# Access Compliance Report

## Public Rights-of-Way

### (Curb Ramps)

Intersection ID: 46200	Main Street: LOROPETALUM_RD	Cross Street: FERNSPRAY_RD	Location: S
ADA ID: DF419354BA55	Ramp Type: Perp	Initial Pass/Fail: Fail	Overall Compliance: No
Severity Score: 22.5			
Codes/Mitigation Info/Possible Solution		Field Measurements/Component Compliance

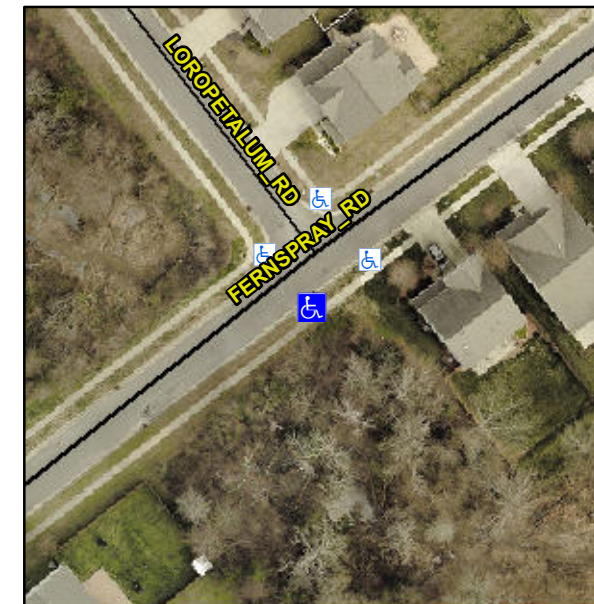
**Not Found, R304.5.1, R304.2.2**

Compliance	Description	Data	Compliance	Description	Data
N/A	Ramp Length (in)	70.5	No	Ramp Slope (%)	8.4
No	Ramp Width (in)	47.0	Yes	Ramp XSlope (%)	2.6
N/A	Flare Type LT	N/A	N/A	Flare Type RT	N/A
N/A	Flare Slope LT (%)	N/A	N/A	Flare Slope RT (%)	N/A
N/A	Flare Traversable LT?	N/A	N/A	Flare Traversable RT?	N/A
N/A	Landing Length (in)	N/A	N/A	DWS Provided?	N/A
N/A	Landing Width (in)	N/A	N/A	DWS Contrast?	N/A
N/A	Landing Slope (%)	N/A	N/A	DWS Length (in)	N/A
N/A	Landing X Slope (%)	N/A	N/A	DWS Full Width?	N/A
N/A	Landing Curb? (Y/N)	N/A	N/A	DWS Offset (in)	N/A
N/A	Shared Landing?	N/A			
N/A	Gutter Ponding?	N/A	N/A	Gutter Slope (%)	N/A
N/A	Gutter Lip Ht (in)	1.5	N/A	Gutter X Slope (%)	N/A
N/A	Painted X Walk1?	No	N/A	Painted X Walk2?	N/A
	X Walk 1 Direction	To NW		X Walk 2 Direction	N/A
N/A	X Walk 1 Width (in)	N/A	N/A	X Walk 2 Width (in)	N/A
	X Walk 1 Slope (%)	2.3		X Walk 2 Slope (%)	N/A
	X Walk 1 X Slope (%)	2.7		X Walk 2 X Slope (%)	N/A

**Remove & Replace Entire Ramp.**
